We are pleased to inform you of an improvement that is on your MVP grill if it was shipped after September 1, 2013.

ADJUSTING GAS FLOW

"LOW" Flame setting adjustment screw.

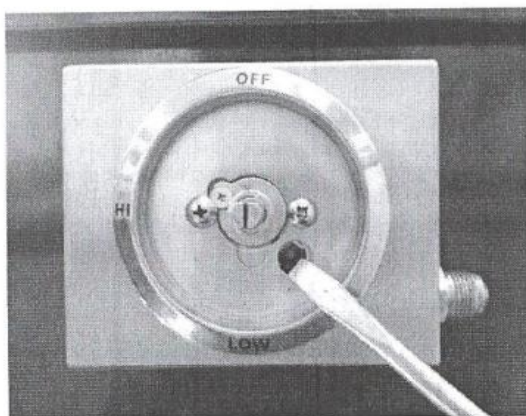
The improvement is to the temperature control valve. Earlier in the year we started using the new adjustable flame valve on the VARSITY grill and it proved to be a valuable improvement so we made it standard on both models. The benefit of this valve is that it allows us to use a higher performance grill for cold weather grilling and still use the same grill in warmer climates. This feature keeps the grill from overheating in warmer climates the low side of the heat can be adjusted. See the information and screen shot below for details on how to adjust. The factory did not get the page below added to the owner's manual so please print this off and include it in your manual.

The "LOW" setting gas flow can be adjusted to raise or lower the minimum heat output of the grill. Note this only affects the "LOW" setting while the "HI" setting will not be affected.

To change setting, first ignite burner and set on "LOW". Remove control knob (The knob uses a small latch, and with enough pressure can be snapped on and off easily.) Using a flat head screwdriver, find the internal brass adjustment screw. Adjust to desired flame size.

(It will be easier to adjust flame size with grill and heat deflector removed)
